S.B. No: 172

**Title:** INSPECTION OF FLAP DRIVE TORQUE TUBE

**Applicability:** T67A, T67B, T67C, T67M, T67M-MkII, T67M200, T67M260 (Pre Mod M950) and T67M260-T3A

**FIGURE 1**

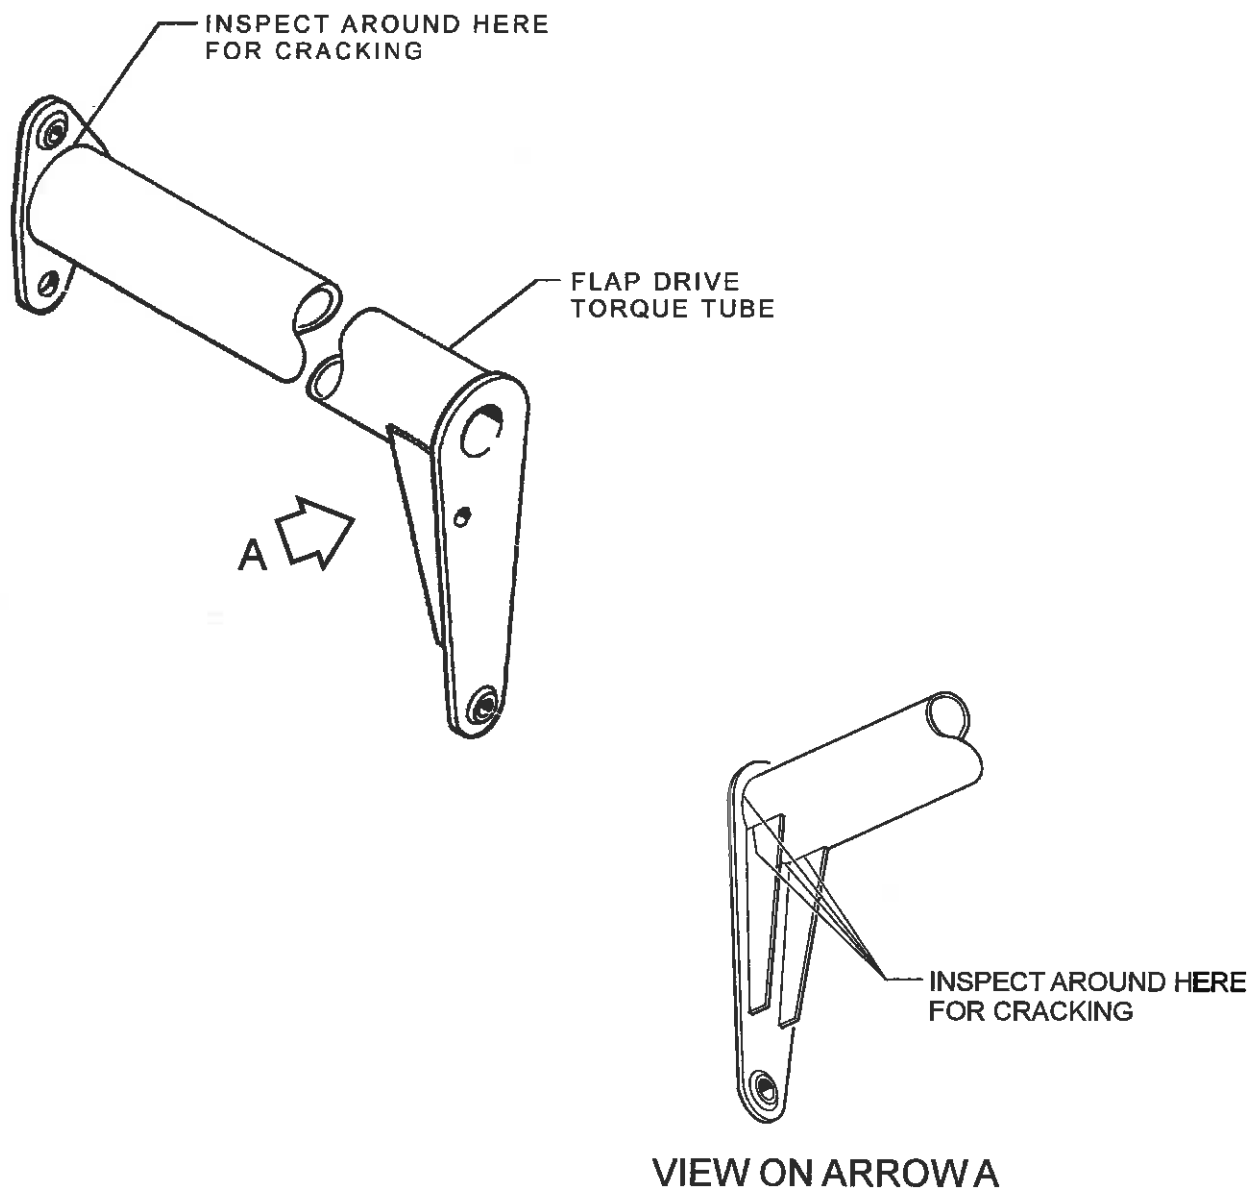
Cases have been reported of cracks at the inboard and outboard ends of the flap drive torque tube.

1. Gain access to the inboard and outboard ends of the flap drive torque tube.
2. Visually inspect for signs of cracking, i.e. flaked paint etc. in areas indicated ref. Figure 1. If in doubt remove paint locally and use dye penetrant as required.
3. If no cracks are present, annotate logbook "SB172 complied with". Note if paint removed, clean and repaint.
4. If cracking is present, obtain new welded item T67G-45-243/244 from Slingsby Aviation Limited. Annotate logbook "SB 172 complied with, Mod M948 invoked".

Note: The incorporation of Modification M948 supersedes the requirements of this Service Bulletin SB 172.
